Service Advisory

W-117

Model: GT-2550 14AZ816P190

Subject: DECK HANGER FOR 50-INCH DECK

Figure 3

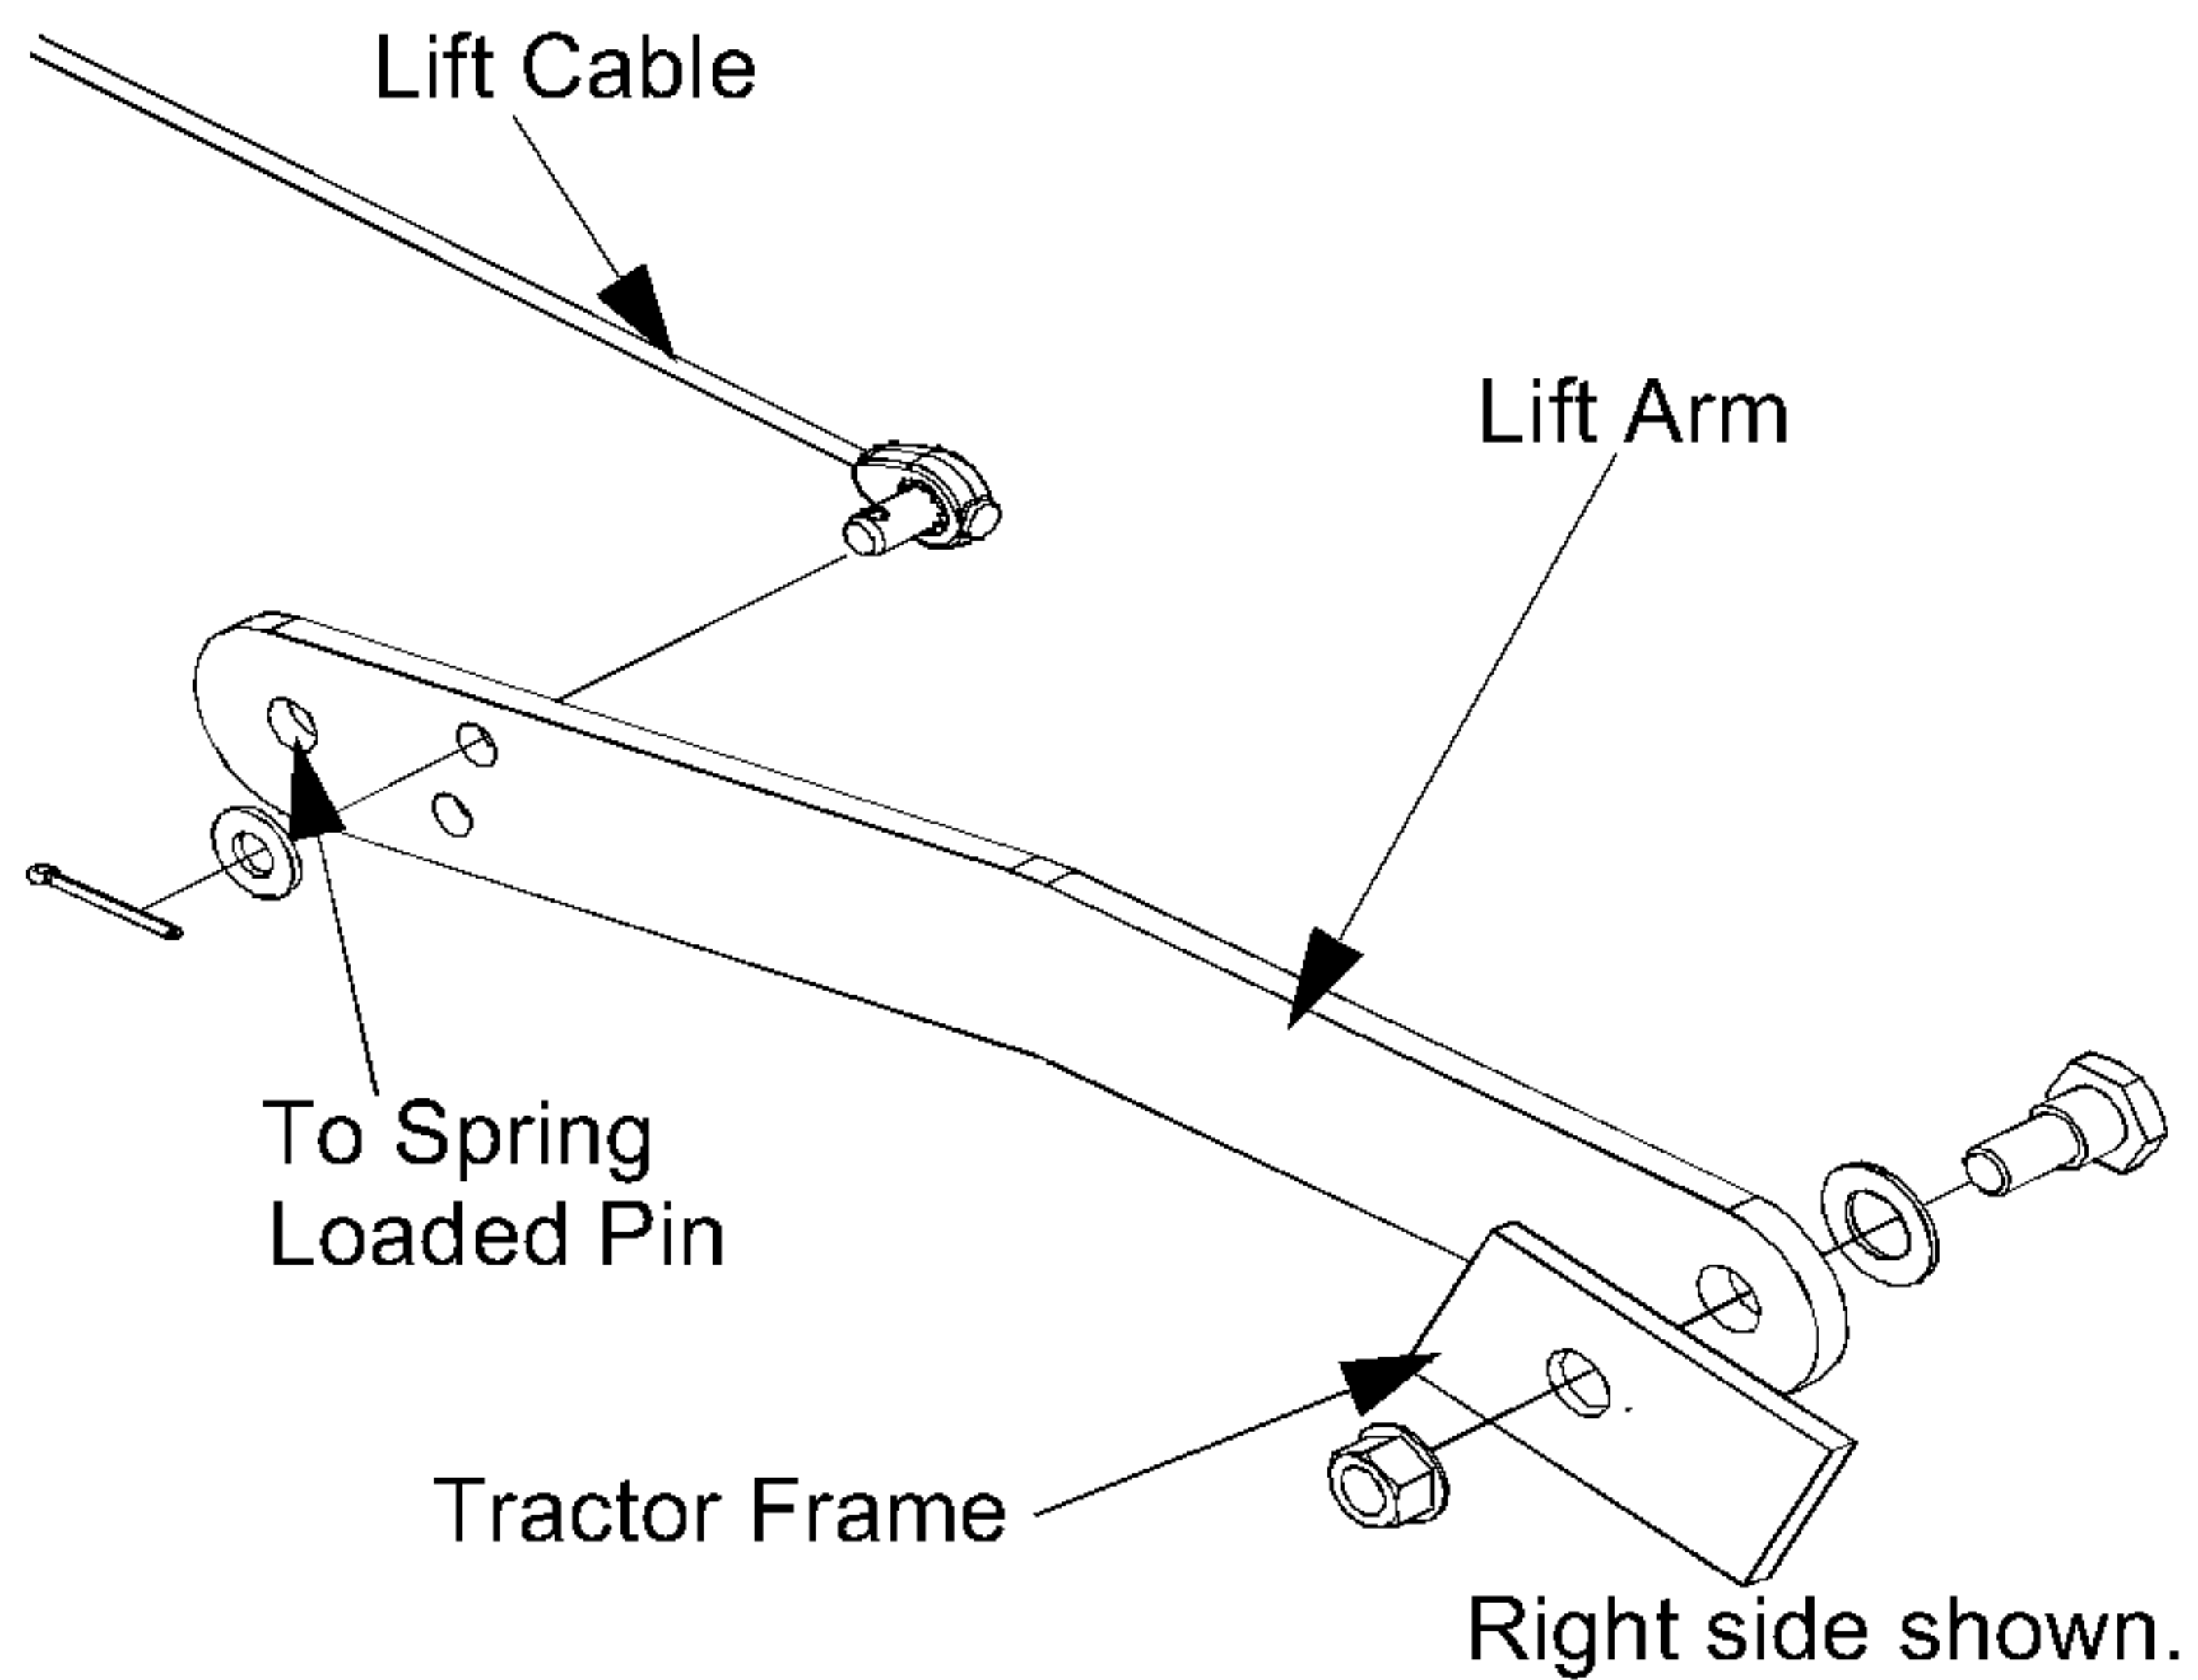
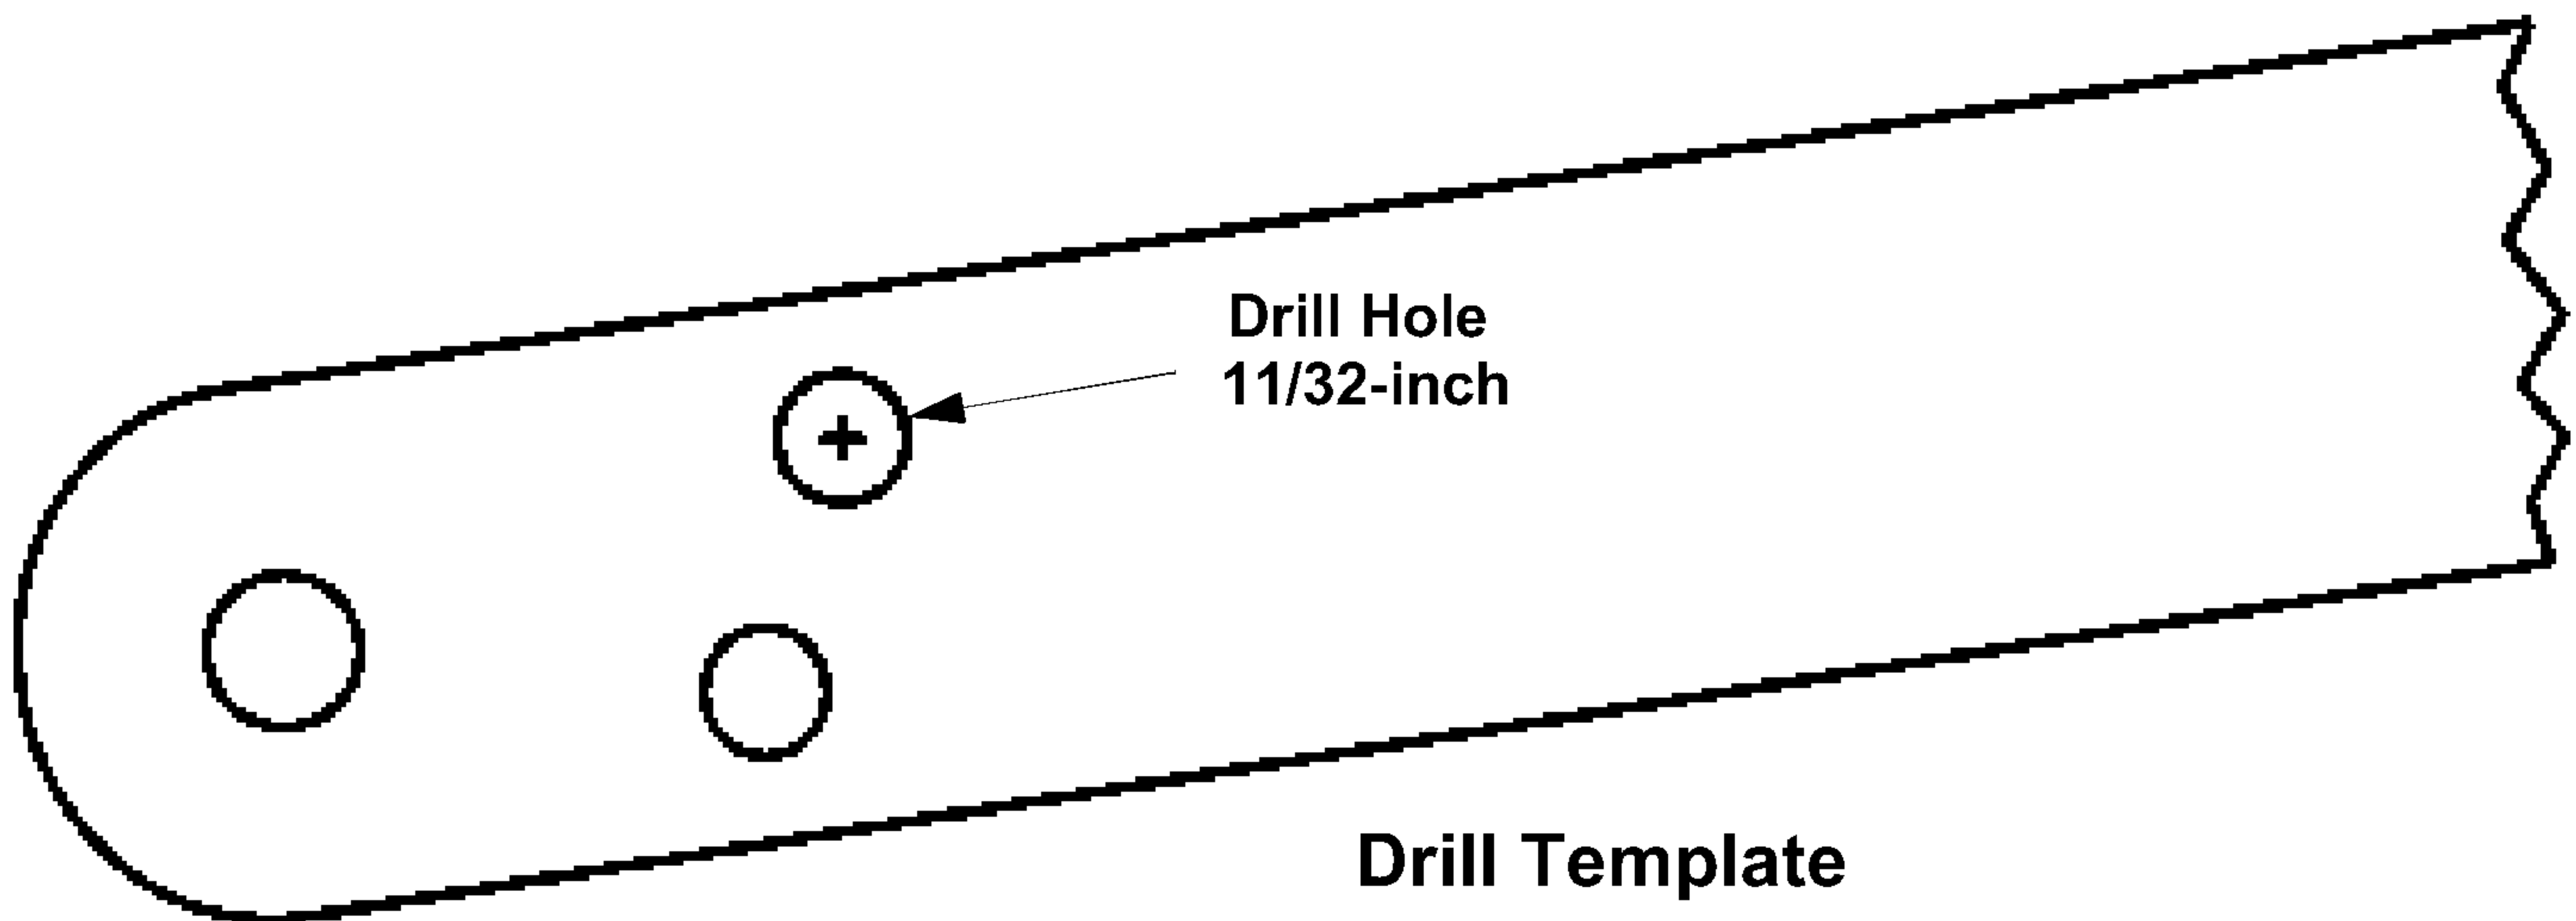
4. Reinstall the lift arms on each side of the tractor with the lift cables in the new upper holes. See Figure 3.

NOTE: Attach the lift arms to the spring loaded pins for the deck last.
